APPLICATION NO.	FILING DATE	FIRST NAMED INVENTOR	ATTORNEY DOCKET NO.	CONFIRMATION NO.
10/696,599	10/29/2003	Gonzalo E. Labarca	CE11909JME	6879

Office Action Summary	Application No.	Applicant(s)	
	10/696,599	LABARCA ET AL.	
	Examiner	Art Unit	
	Justin M. Larson	3727

DETAILED ACTION

FIG. 3

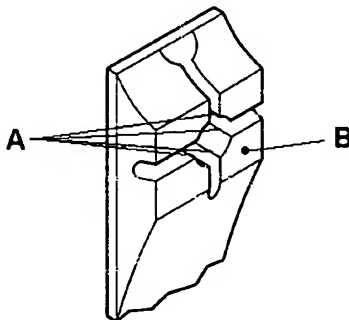
- A. Figure 3 does not show the central cavity being spherical, as recited in claims 4 and 6 and better shown in Figures 4 and 5. As shown below, walls A project straight down from flat, upper surface B, indicating that the cavity is cylindrical in shape, not spherical. There would be some curvature to walls A if the cavity were in fact spherical.

3. Corrected drawing sheets in compliance with 37 CFR 1.121(d) are required in reply to the Office action to avoid abandonment of the application. No new matter should be entered. Any amended replacement drawing sheet should include all of the figures appearing on the immediate prior version of the sheet, even if only one figure is being amended. The figure or figure number of an amended drawing should not be labeled as "amended." If a drawing figure is to be canceled, the appropriate figure must be removed from the replacement sheet, and where necessary, the remaining figures must be renumbered and appropriate changes made to the brief description of the several views of the drawings for consistency. Additional replacement sheets may be necessary to show the renumbering of the remaining figures. Each drawing sheet submitted after the filing date of an application must be labeled in the top margin as either "Replacement Sheet" or "New Sheet" pursuant to 37 CFR 1.121(d). If the changes are not accepted by the examiner, the applicant will be notified and informed of
